The Value of Rapid Reviews THE UNIVERSITY OF TEXAS MDAnderson Jessica R. Lowenstein, Joye Roll, Ashley Hollan, Hannah Nguyen and David Followill **Department of Radiation Physics** Cancer Center The University of Texas, M.D. Anderson Cancer Center, Houston, Texas

Describe the value of rapid (pre-treatment) reviews within the clinical trial environment.

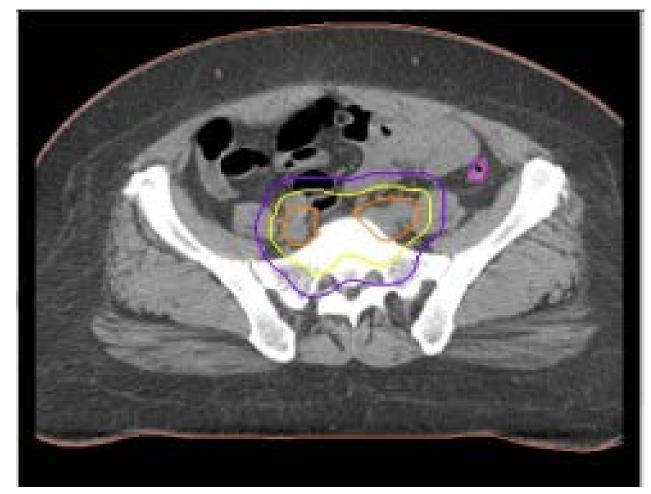
Original Submission reSubmission Clinical Comments: Femurs: slices -7.3 and -7.55 have bone contours outside the bone

Figure 2

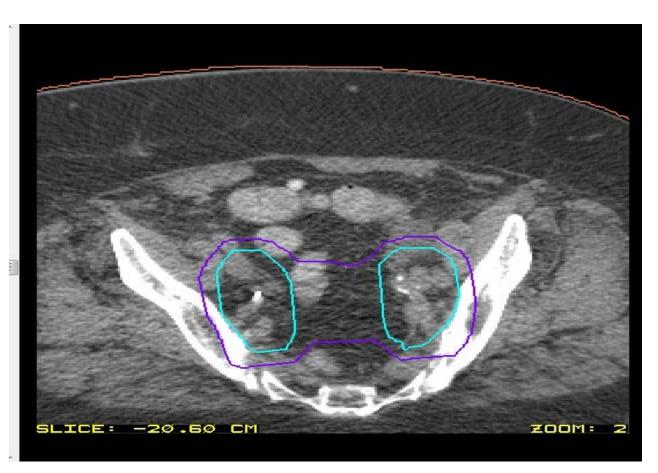
Clinical Comments: For the lymph node volume the CTV needs at least a 6mm margin on the vessel. It appears that the attempt was to draw around the vessels, then add a vessel PTV to serve as the CTV but there are areas where the vessel contouring cuts directly thru a vessel and the PTV no longer gives margin on the vessel. In addition the vagina/CTV was not contoured according to atlas (4.2931) there for the anterior and posterior margin are too large (some margin into the bladder and rectum is acceptable if no ITV but these contours include virtually the entire rectum and bladder) and the lateral margins are too small

Figure 3

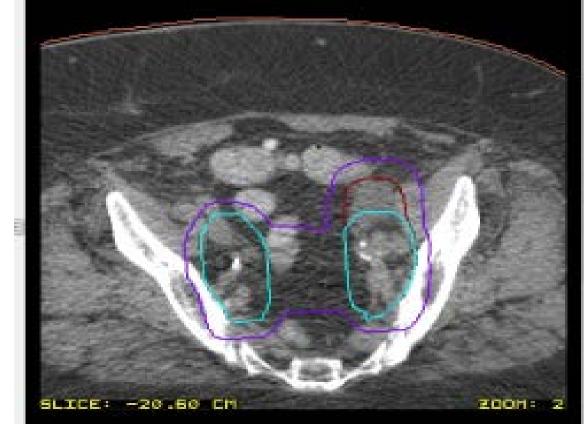
Clinical Comments: The left external iliac nodal CTV should come more anterior, it does not cover the seroma that is present. Specifically on slices 20.6-22.4 the seroma is NOT covered and on slice 22.7 it is just covered by the PTV. Slices 19.7-20.3 have the very top of the seroma and only are included in the PTV not the CTV
